Application Number P24-06

Semi-Truck and Trailer Parking-Storage and Office

Property Owner: JPA Trucking LLC
Applicant: Norman Saeger
Location: South Side of Branch Rd. - East of Commerce Dr (Parcel Number 029-19A-14-021)
Zoning: I-1 (Industrial)
Request: Site Plan approval for a semi-truck and trailer parking-storage area and an office

JPA Trucking LLC Project
10XX Branch Road

PROPOSED SITE PLAN PHASE 1
SCALE 1" = 20'-0"

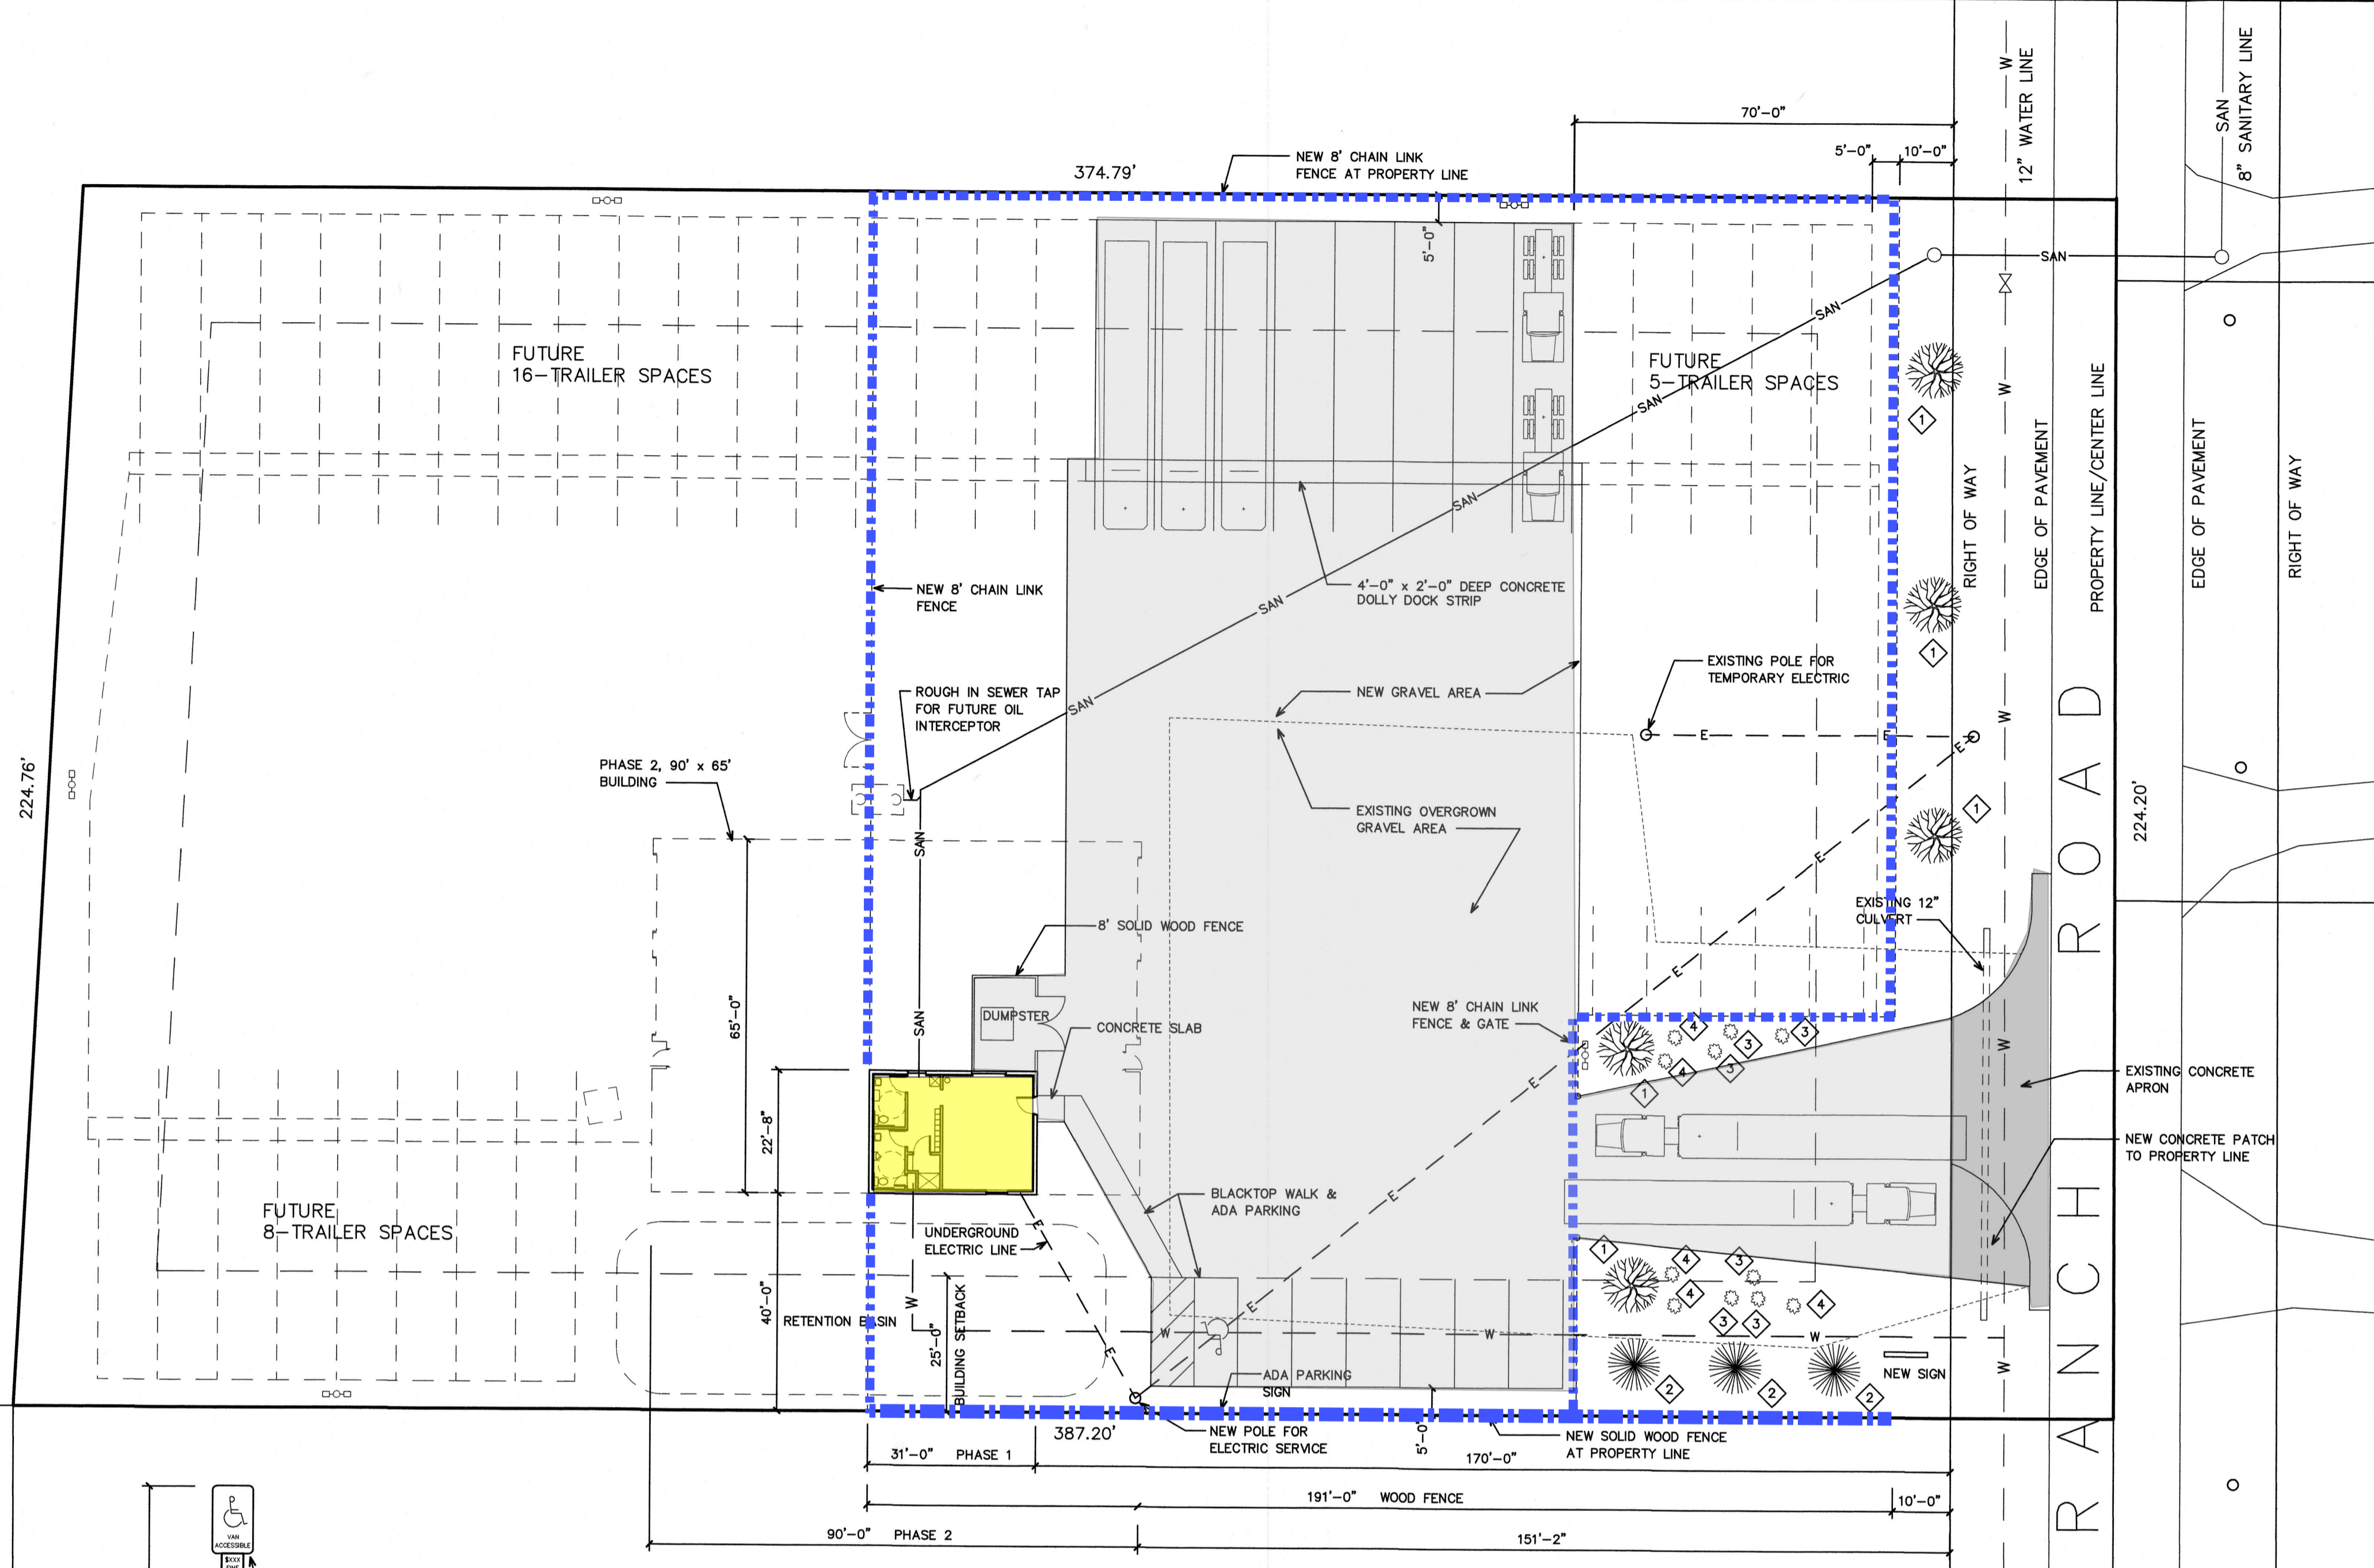
Parking Setback – Per Section 1145.04(g), parking areas must be setback 10 ft. from the right-of-way. The parking area is setback approximately 70 ft. from the right-of-way.

Access and Circulation – The proposed site has an existing access drive that is proposed to be expanded. Section 1145.10(e) requires that access drives must be between 24 ft. to 60 ft. wide at the right-of-way and a maximum of 120 ft. wide at the curb line. Access drives have been revised to meet the required widths.

Required Off-Street Spaces – Office uses require 1 space per 400 sq. ft. of floor area and warehouse and a semi-truck and trailer storage use requires “enough to satisfy all the parking needs of the proposed use”. 7 parking spaces are provided on the east side of the site, which appear to be sufficient.

Surface Materials – Section 1145.09(a)(3)(A.) requires that parking and drives must be hard surfaced between the right-of-way and the rear of the building. The section further indicates that gravel may be utilized beyond the rear of the building in industrial areas. All parking areas and drives are required to be a hard surface and gravel is proposed. The applicant has filed a variance request to the Board of Zoning Appeals regarding this requirement.

Section 1145.09(b) requires a 10 ft. wide landscape strip between the right-of-way and a parking area. The section further requires landscaping materials or other visual barriers in the landscape strip. A landscaped strip is located between the right-of-way and the parking area.

The property is adjacent to permitted nonconforming (grandfathered) single-family homes to the east and the north, on the opposite side of Branch Road. An 8 ft. solid wood fence has been indicated along the eastern property line to provide screening. As noted, landscaping is also provided between the Branch Road right-of-way and the parking area. Staff suggests additional screening in this area, which may include landscaping, slats in the chain link fencing, or other methods.

1. Additional screening shall be added between the access drive and the north property line near the Branch Road right-of-way.
2. The project shall comply with Planning and Zoning Code Section 1145.09(a)(3)(A.) regarding the use of a gravel surface for parking and drives or a variance shall be approved by the Board of Zoning Appeals.

1. Please refer to the attached engineering checklist for site plan approval.
2. As referenced in the attached, a storm water management and sediment control analysis will be required
3. Plans indicate the existing concrete apron will be increased in size, though no dimension is shown. Please note the City's regulations for maximum width of driveway aprons:

JPA Trucking - Site Lighting Plan

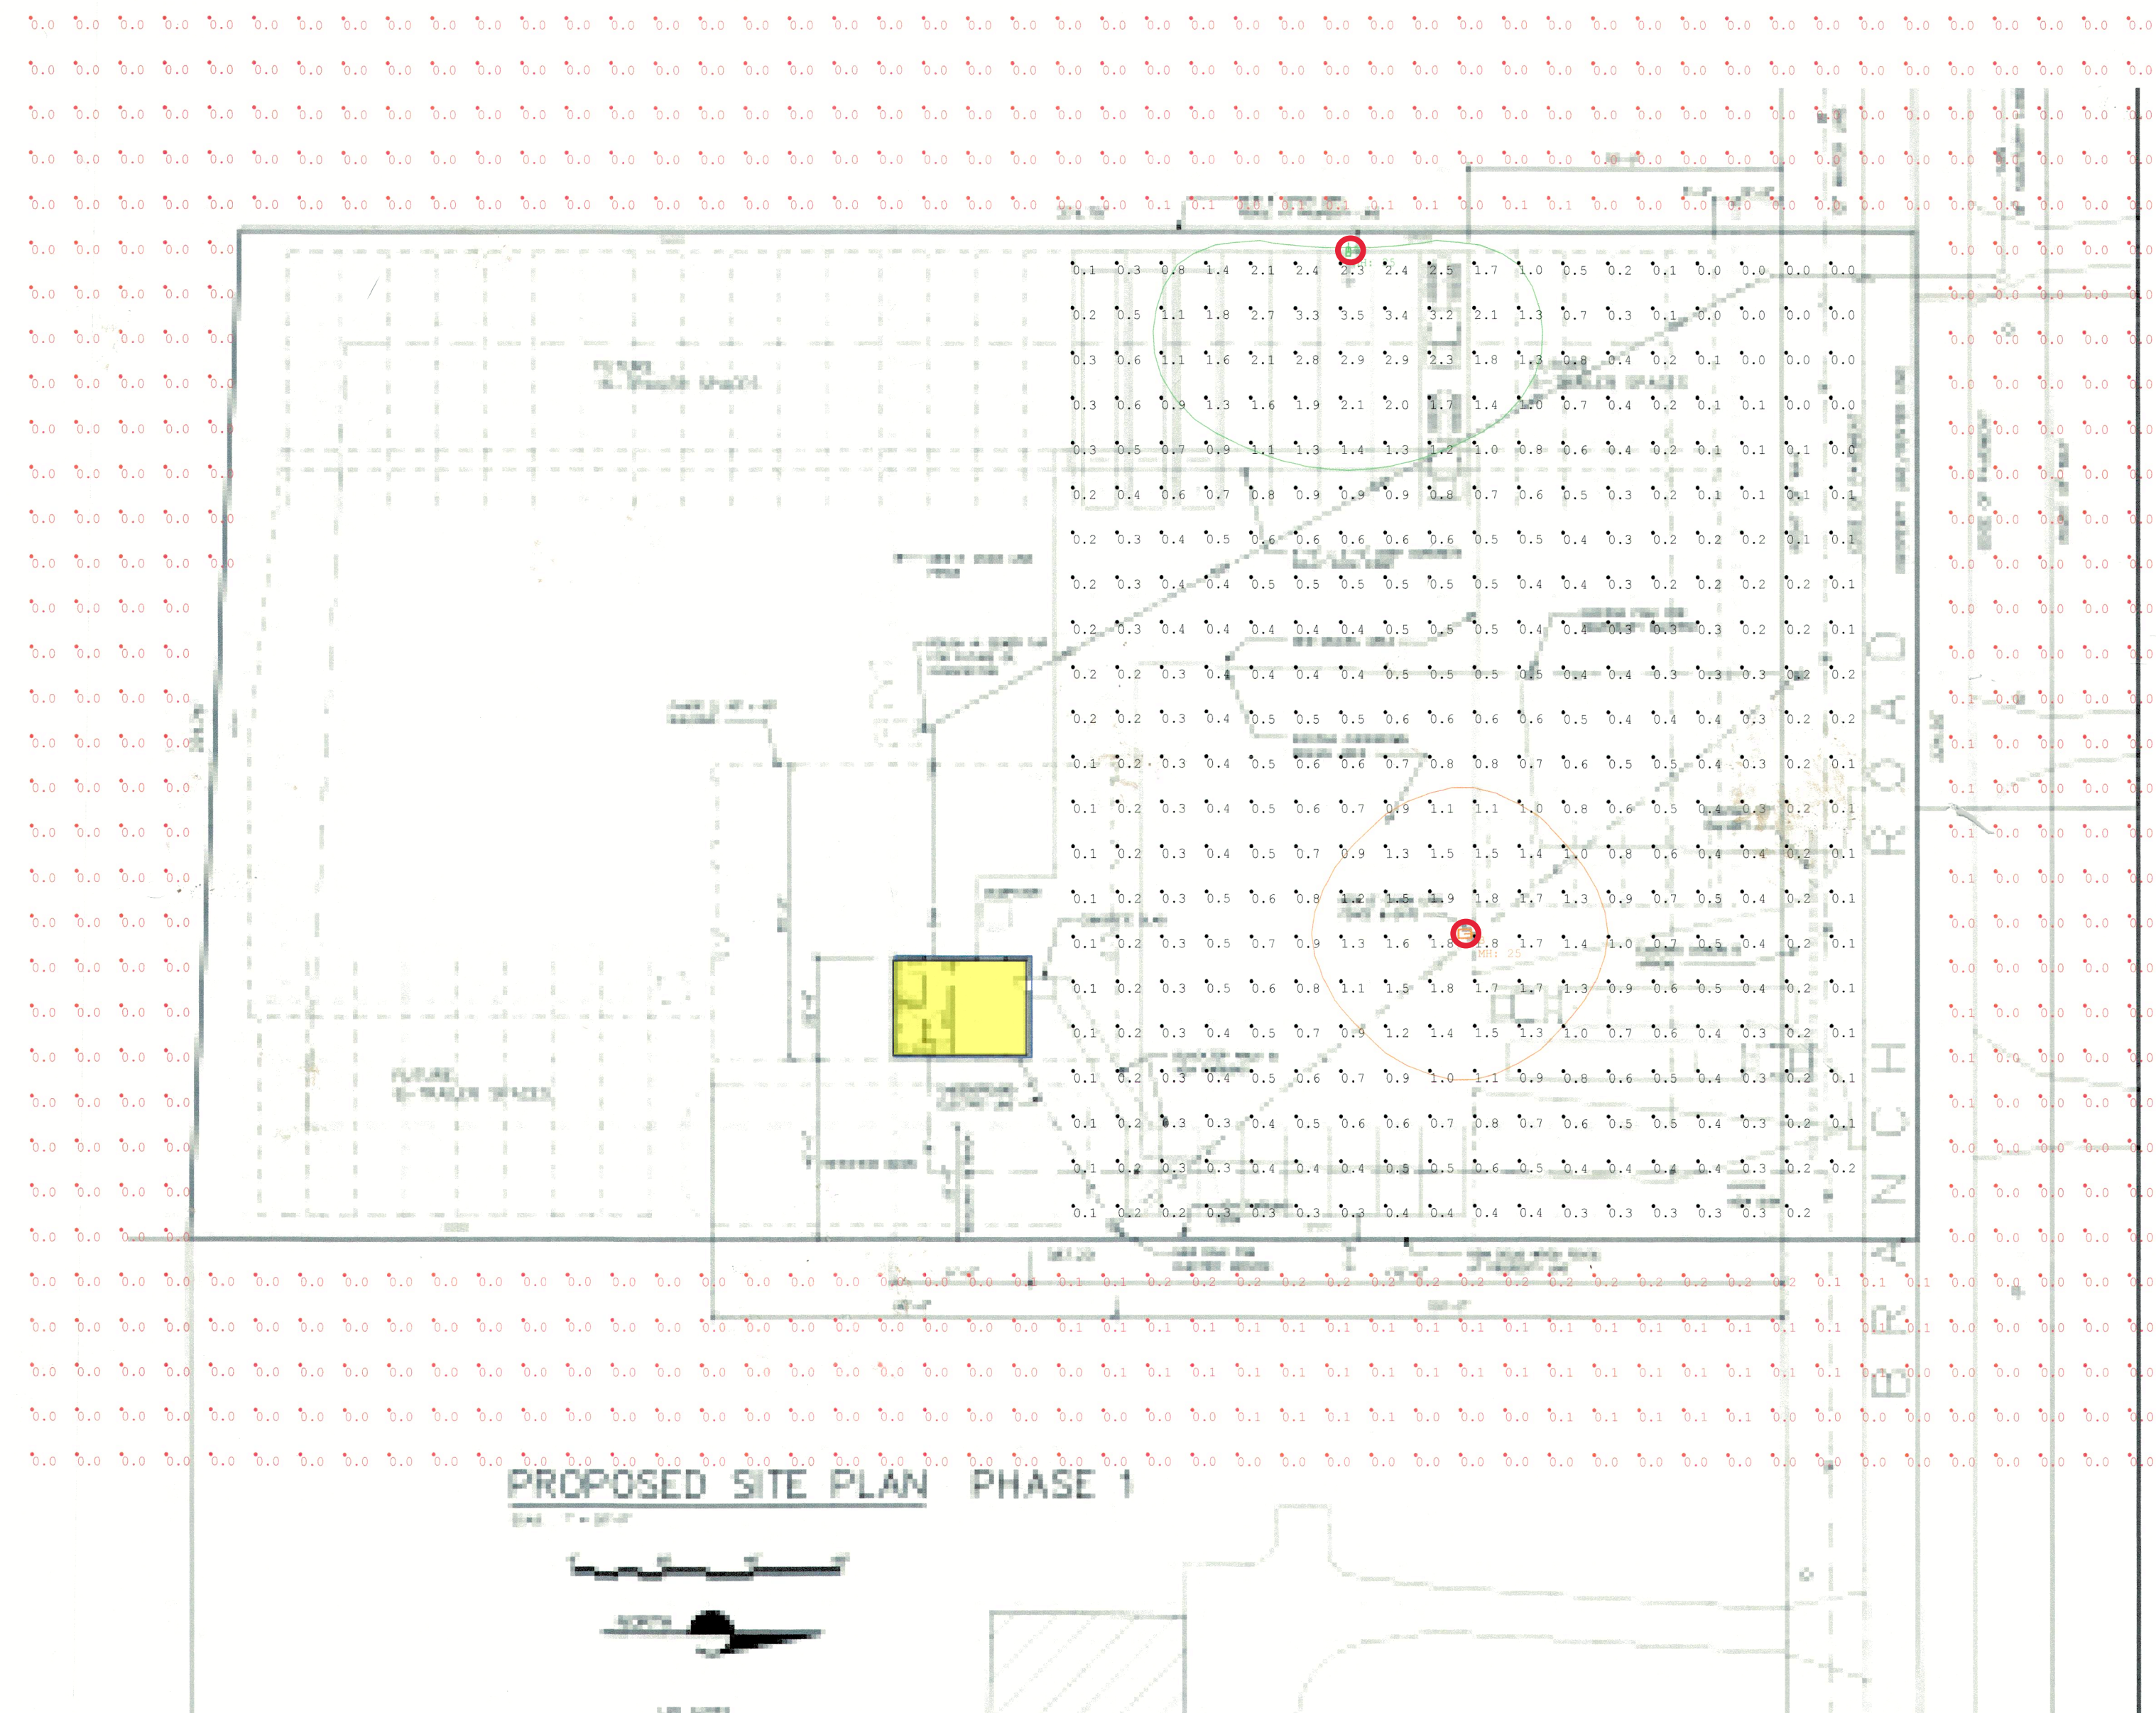
Section 1145.09 requires lighting to have a maximum height of 25 ft., full cut-off light fixtures that shine straight down, and a photometric plan. A lighting plan has been provided with a compliant light height, fixture, and photometric plan.
